COVER DOCUMENT

System Pillar / EULYNX

Baseline Set 4 Release 3

Error corrections

F_Control_4W_PM

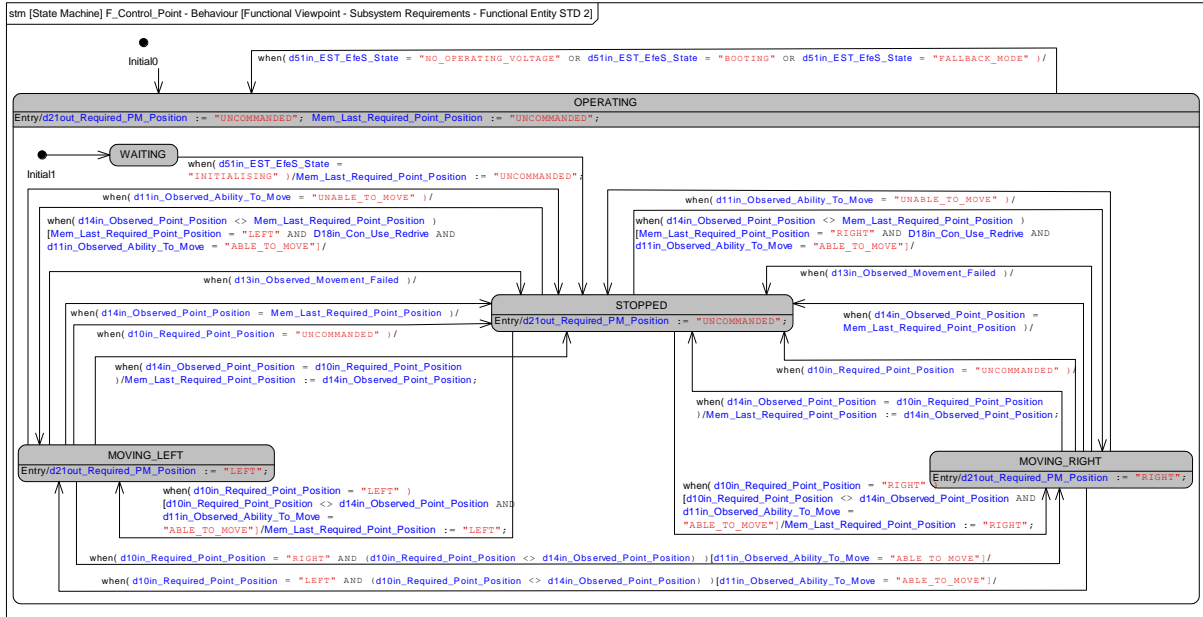
The STM diagram F_Control_And_Observe_4W_PM (Eu.P.5823) contains an error. The 2nd transitions from MOVING_LEFT_PM / MOVING_RIGHT_PM to DETECTION contain `d12in_Required_PM_Position = "LEFT_REACHED" / d12in_Required_PM_Position = "RIGHT_REACHED"`. This condition can never be true, because the values "LEFT_REACHED" / "RIGHT_REACHED" are not used for the port `d12in_Required_PM_Position`.

The correct transition must be `d27in_4W_PM_Position = "LEFT_REACHED" / d27in_4W_PM_Position = "RIGHT_REACHED"`.

The correct transitions are shown in the attached figure.

Attachments:	 Figure SDI-IO multiplicity corrections.png
---------------------	--

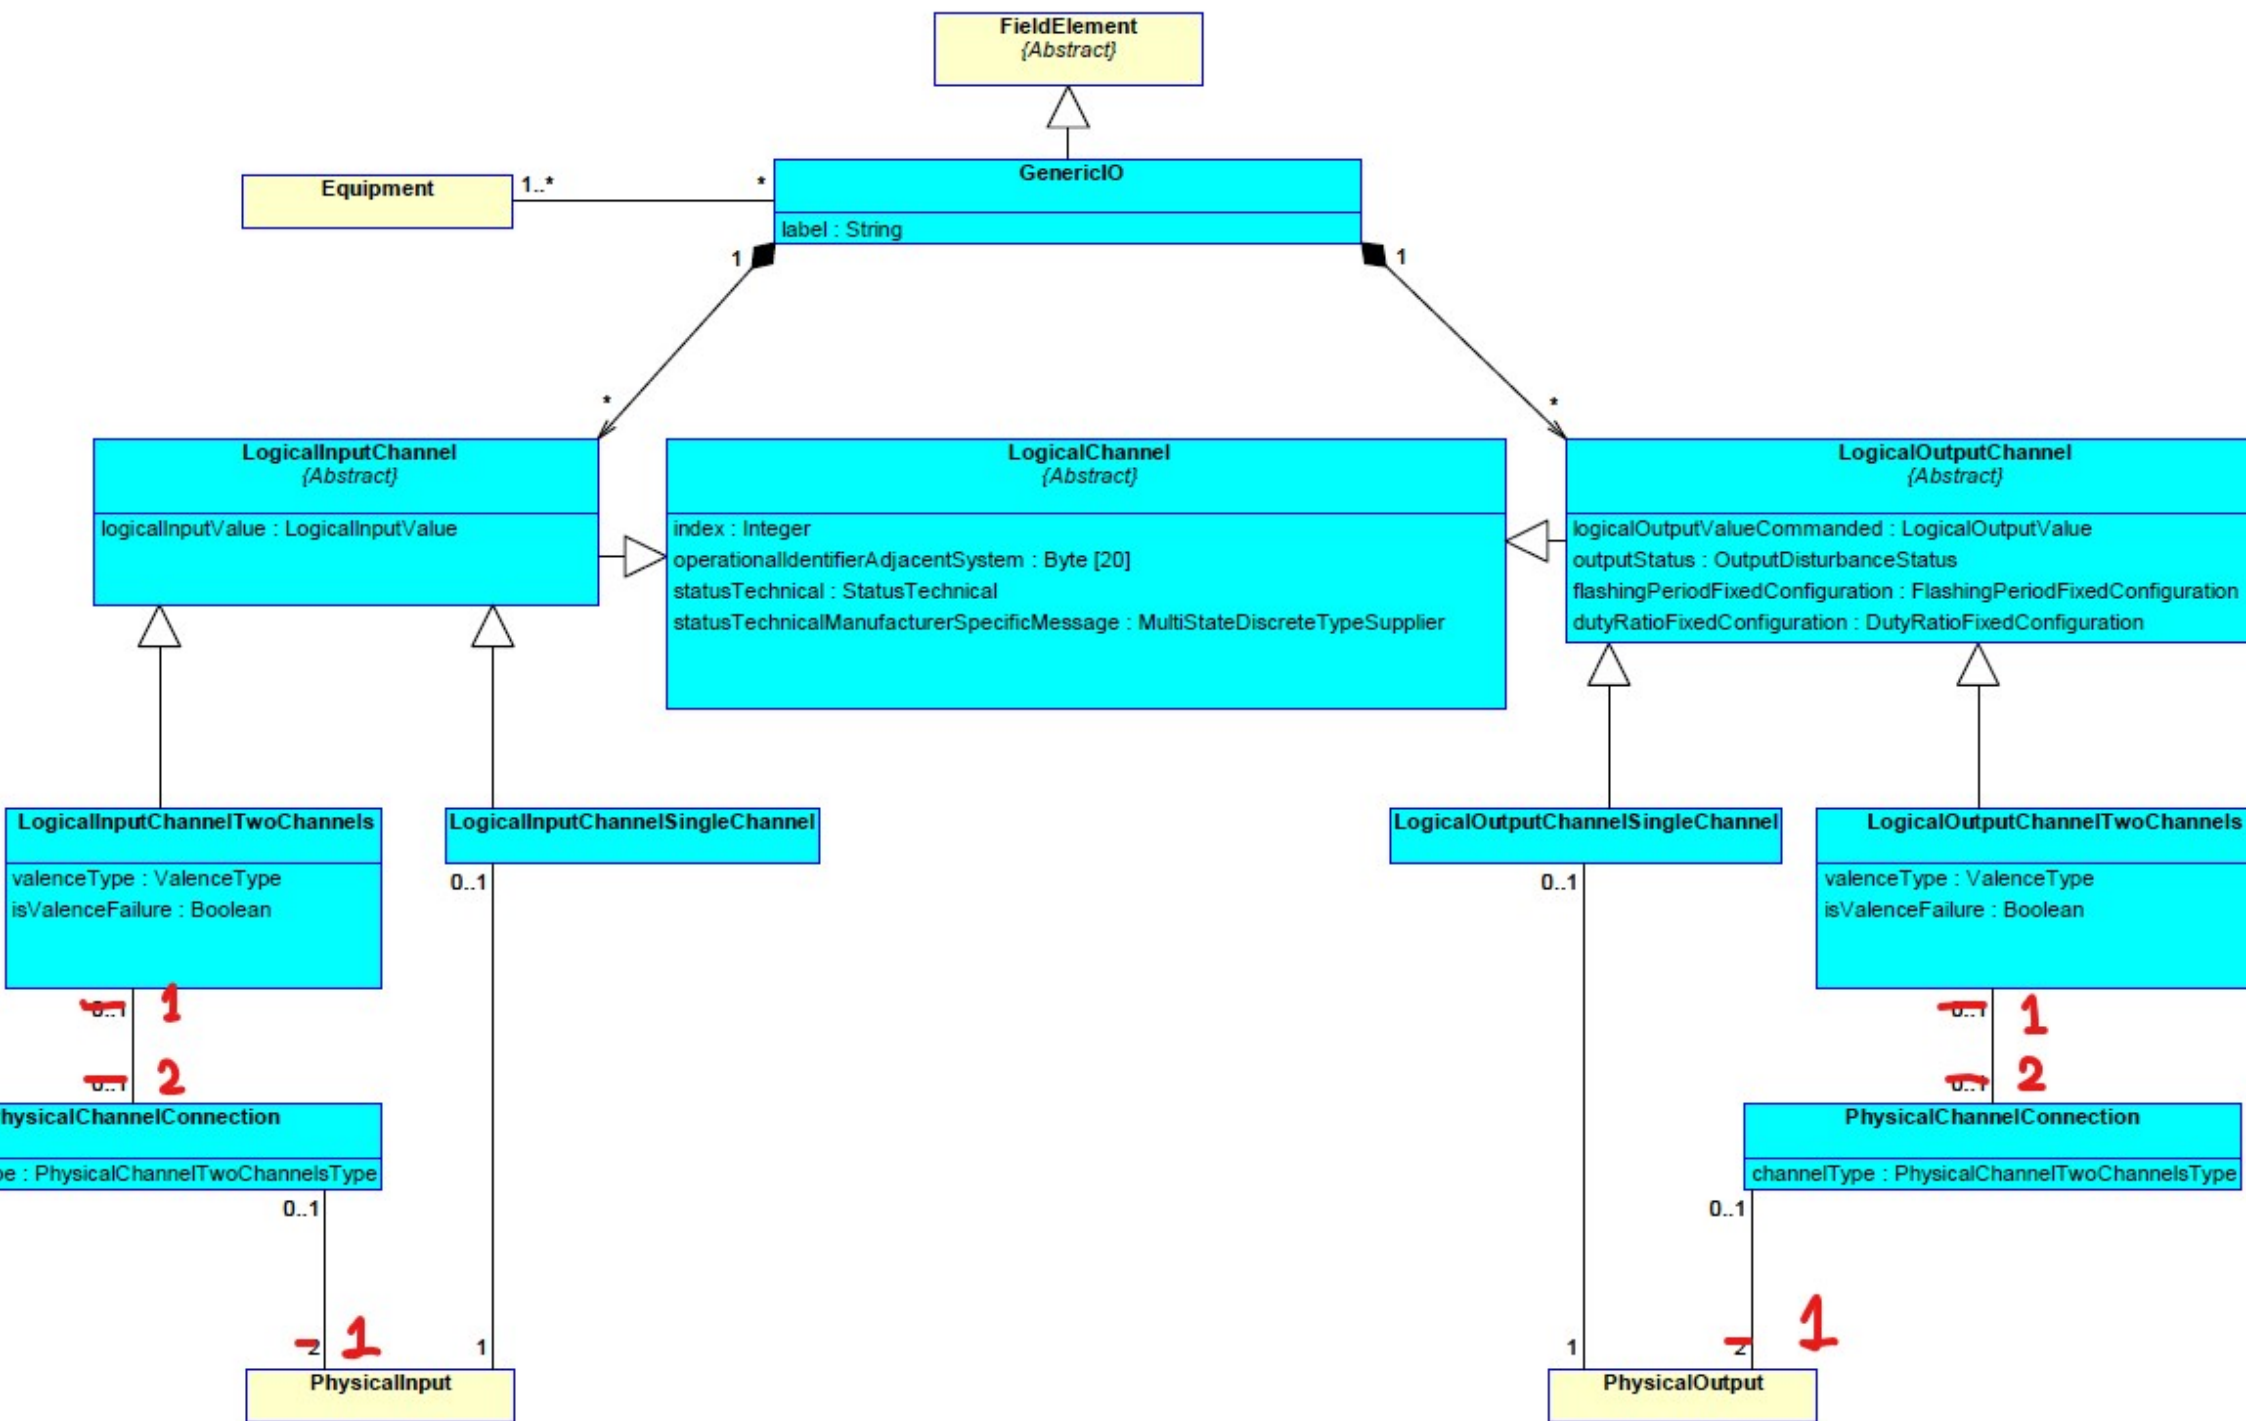
Problem
The multiplicities between LogicalInputChannelTwoChannels, PhysicalChannelConnection and PhysicalInput are incorrect.
Also valid for the multiplicities between LogicalOutputChannelTwoChannels, PhysicalChannelConnection and PhysicalOutput.

Intended state
See figure.
